CITY OF WEST DES MOINES STAFF REPORT COMMUNICATION

ITEM: Wendy's PUD, 225 & 301 Grand Avenue - Establish the Wendy's Planned Unit Development Ordinance to govern development of a Wendy's restaurant – Wendy's West Maple, L.L.C. – ZC-004998-2021

RESOLUTION: Approval to Establish a Planned Unit Development Ordinance

WENDY'S PUD SKETCH

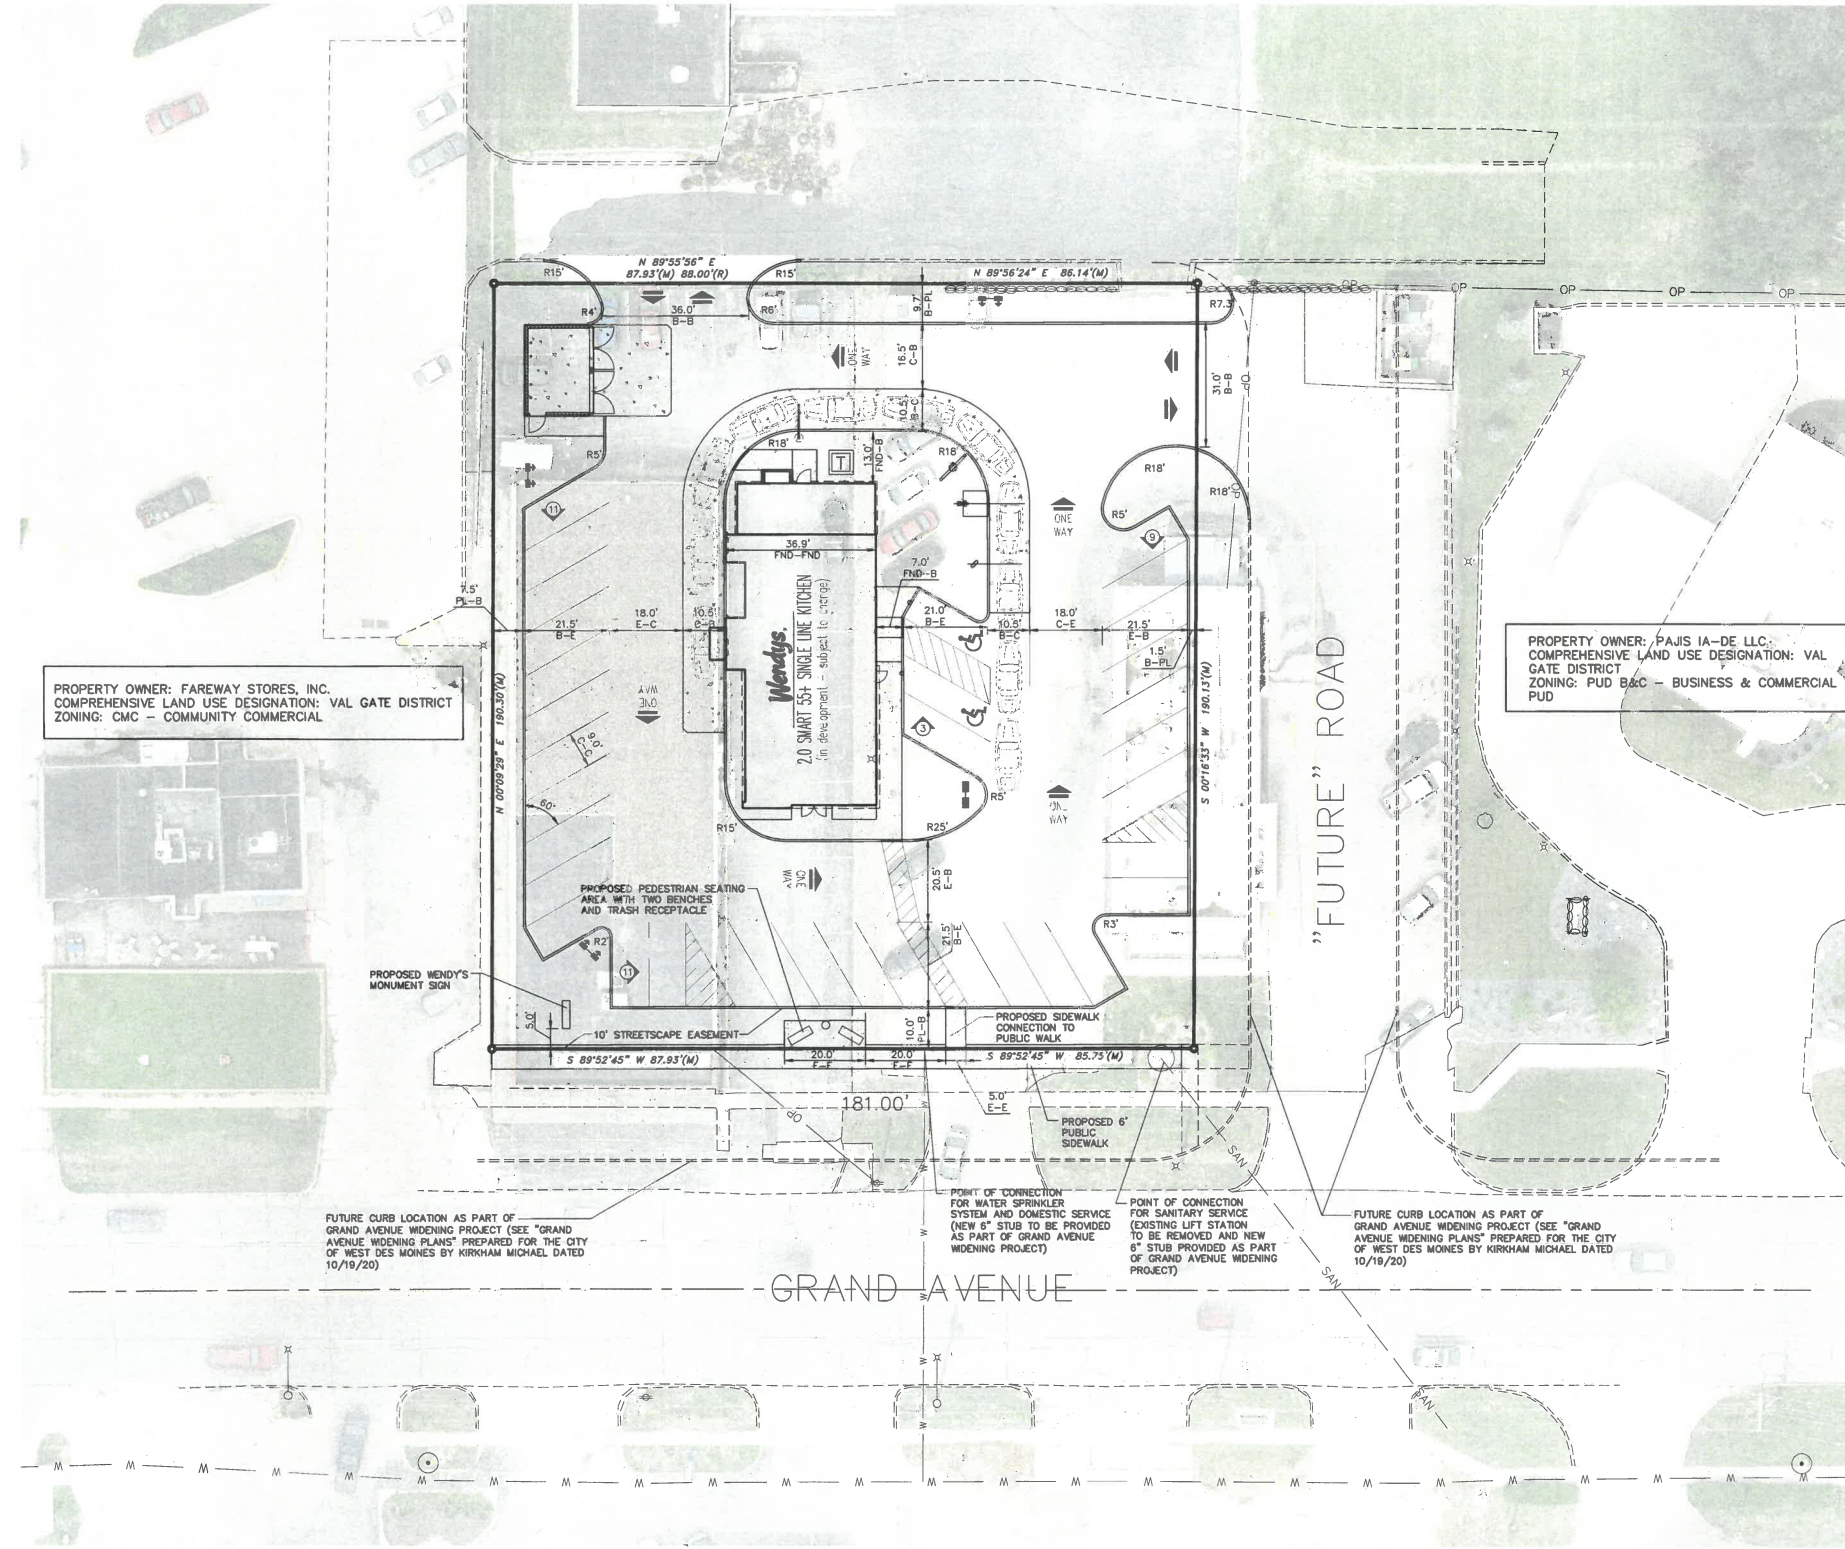
- **Setbacks:** Due to the smaller lot size of this site and area as a whole, the setbacks from the adjacent rights of way (north, east, and south) are proposed to be reduced to 30' instead of the required 100'. Off street parking lot setbacks are proposed to be reduced as well from the required 15' from public street rights of way, specifically, the parking lot will be a minimum of 9' from the north, 1' from the east property line and 10' from the south property line.

- Monument Sign: A 5' tall, up to 35 square foot monument sign is proposed on the site, which meets current code requirements. However, due to the compact nature of the site, a 5' setback from adjacent property lines is proposed instead of the current City Code requirement of a 10' setback.

- Parking: City Code requires 15 spaces per 1,000 square feet of gross floor area for a restaurant with a drive thru. The PUD Ordinance proposes 12 parking spaces per 1,000 gross square feet of building area. The PUD sketch indicates 34 parking spaces on the site, which will meet this requirement.
